**HEARING STATEMENT**

**In support of proposals for the partial demolition of the existing building,  
construction of a first floor extension and change of use of the  
whole building to form one dwelling house at:-**

**150 Haverstock Hill  
Hampstead  
London  
NW3 2AY**

**CTP Ref: ITP/5792  
LPA Ref: 2016/2507/P  
PINS Ref: TBA**

# **APPENDIX 1**

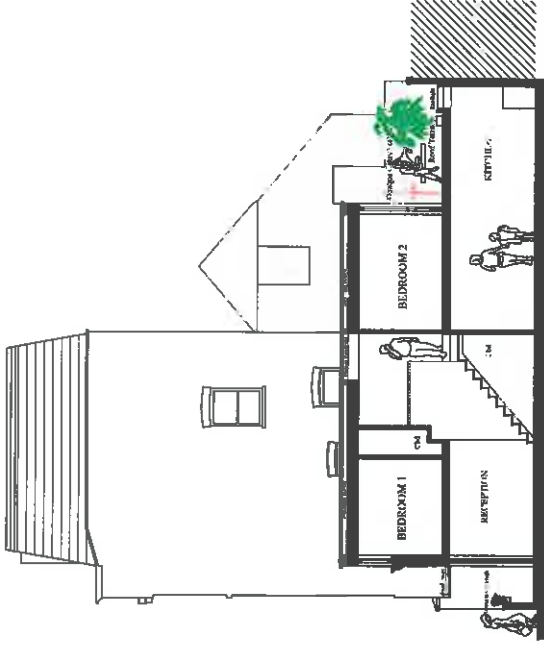
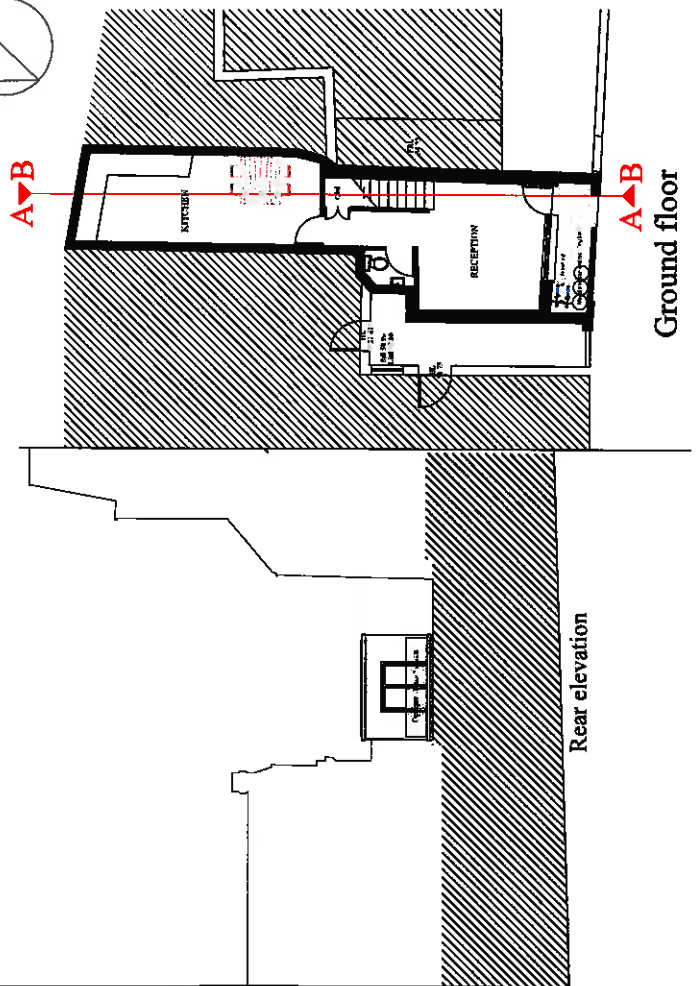
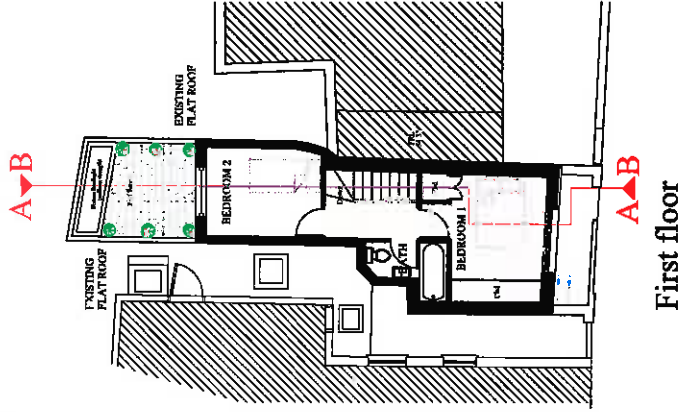
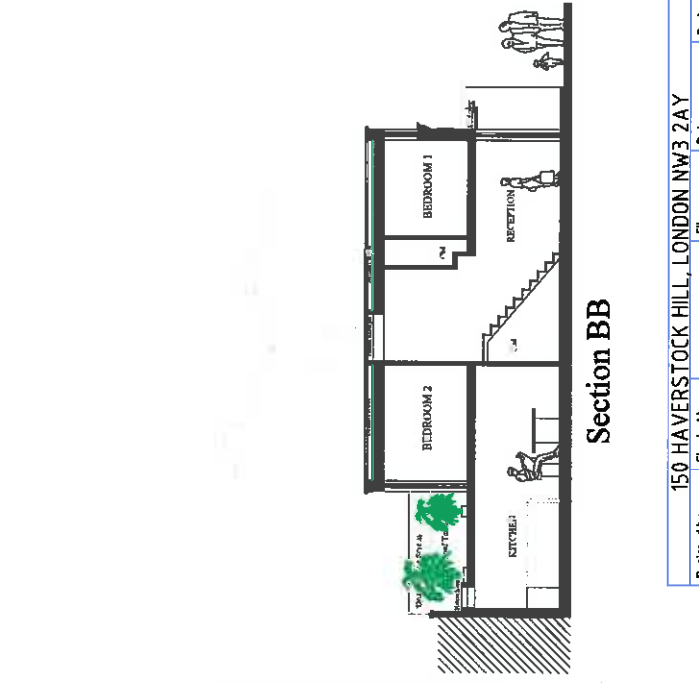
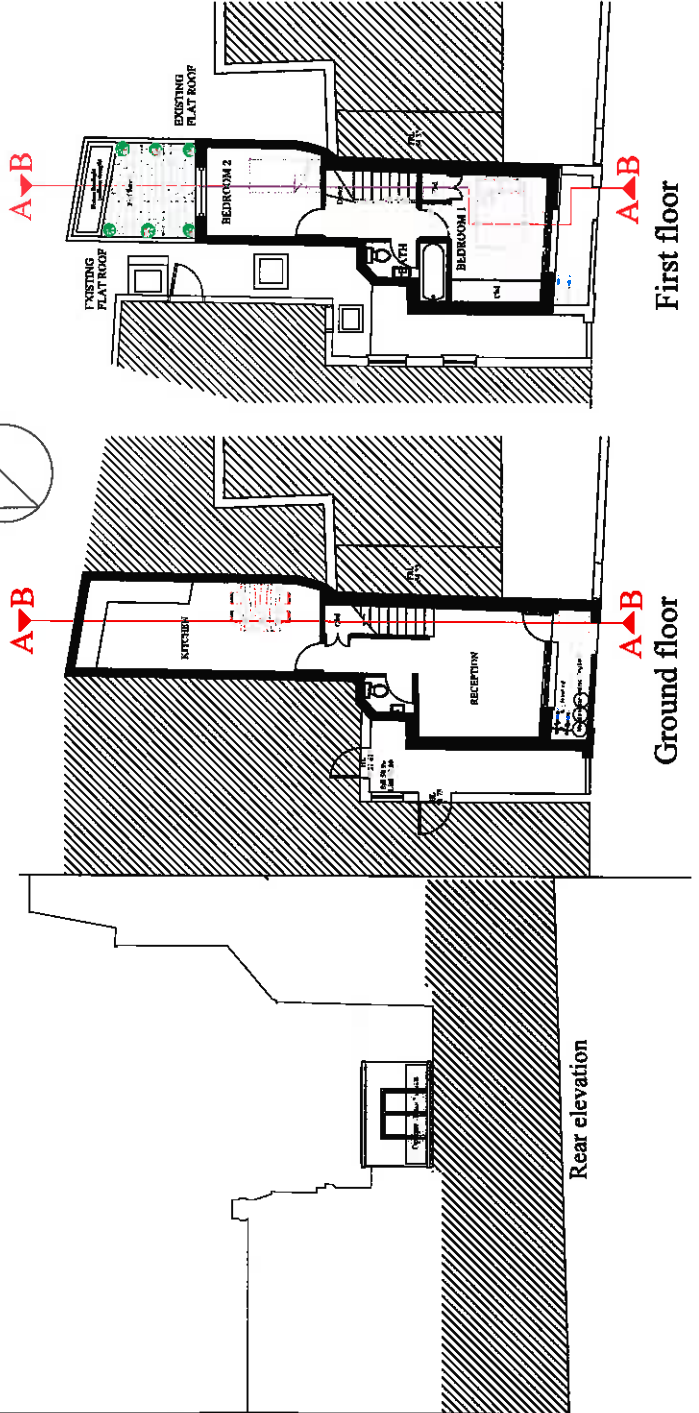
It was subsequently noted that the glazed screen was incorrectly shown positioned on top of a low wall enclosing the terrace, thereby increasing its height. This error was pointed out to the Planning Officer who declined the offer of a revised plan in light of other objections to the proposals, but the plan has now been corrected and a copy is enclosed at Appendix 1. The inspector will be requested to take this into account in determining this appeal.

- 4.22 Notwithstanding the above submissions, the appellants architect has re-assessed the design approach in light of the comments made by the Conservation Officer. The plan enclosed at Appendix 1 also includes a revised front elevational treatment for the proposed new house, now incorporating a cornice line below the first floor window to replicate the shopfront and retained pilasters on the street frontage, as the right hand side of the shop would appear to have originally formed part of the entrance portal to the listed building itself. Computer generated images of the new development are included at Appendix 6. The inspector will be requested to take this revised plan into consideration in determining this appeal.

It should be noted that the revised plan also incorporates some small changes to the front elevation of the proposed building, and these are further explained in evidence below.

Incidentally, I have belatedly noticed one small error on the submitted plan/elevation. The opaque glass screen around the rear roof terrace should be a maximum of 1.8m from top to bottom to ensure privacy for neighbours and the occupants of the new house, and not 1.6m on top of the wall enclosing the balcony as shown. Its only a small point but I can get it changed if you wish.

# **APPENDIX 7**

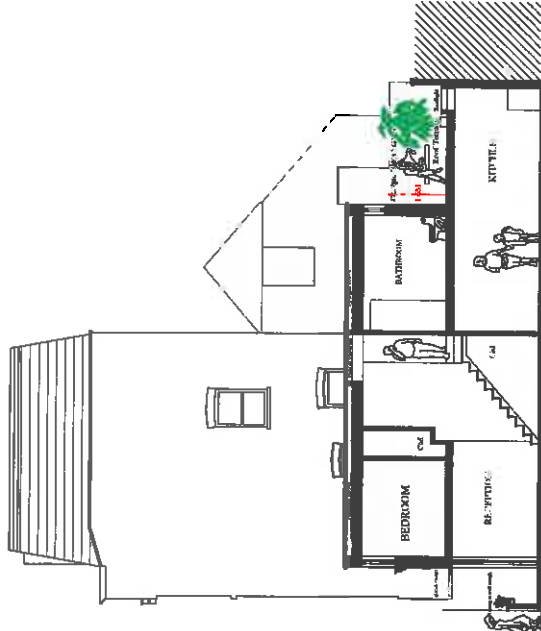
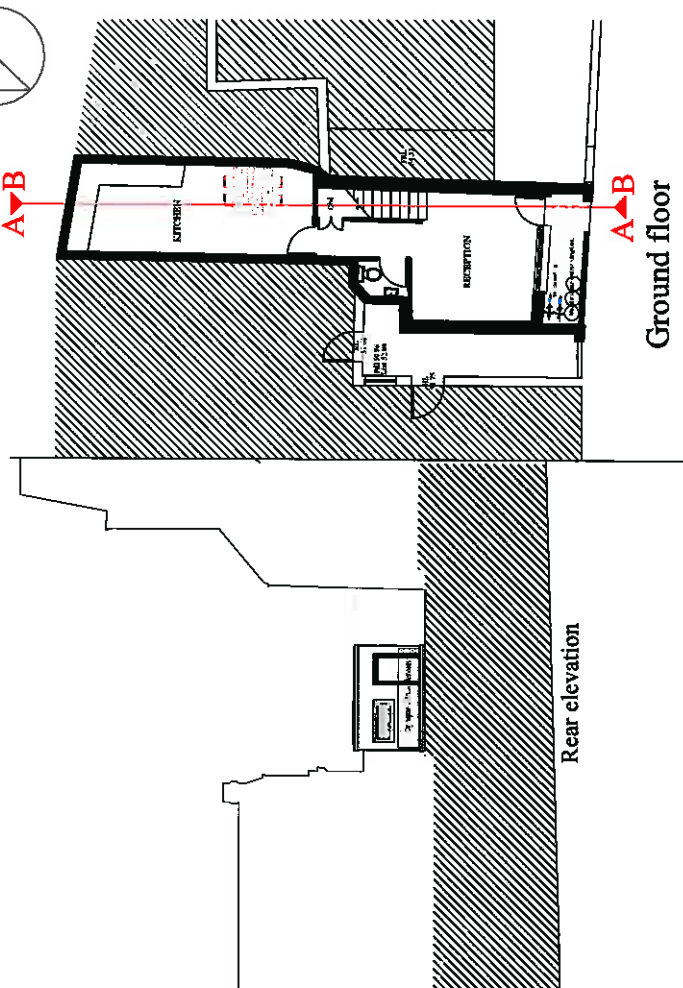
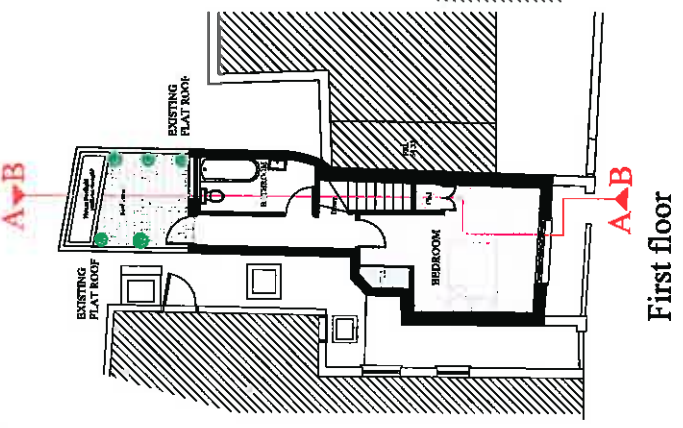
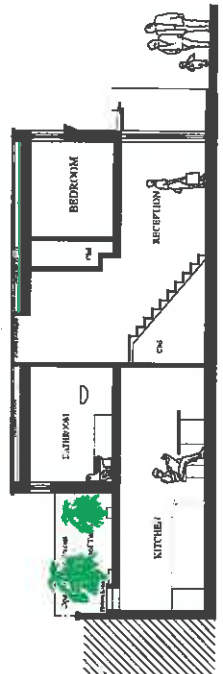
- 4.31 Without prejudice to the appellant's view that the appeal proposals provide an adequate standard of accommodation, the appellant has reviewed the internal layout to provide a two person one bed house and a revised plan is included at Appendix 7. This plan similarly incorporates the changes to the front elevation and the corrected balcony screen as discussed above. The appellant was not afforded an opportunity to present this alternative layout to the lpa during the application process and so, in the event that the inspector concludes that the Councils objection to the standard of accommodation is justifiable, it is requested that consideration be given to this alternative layout instead.
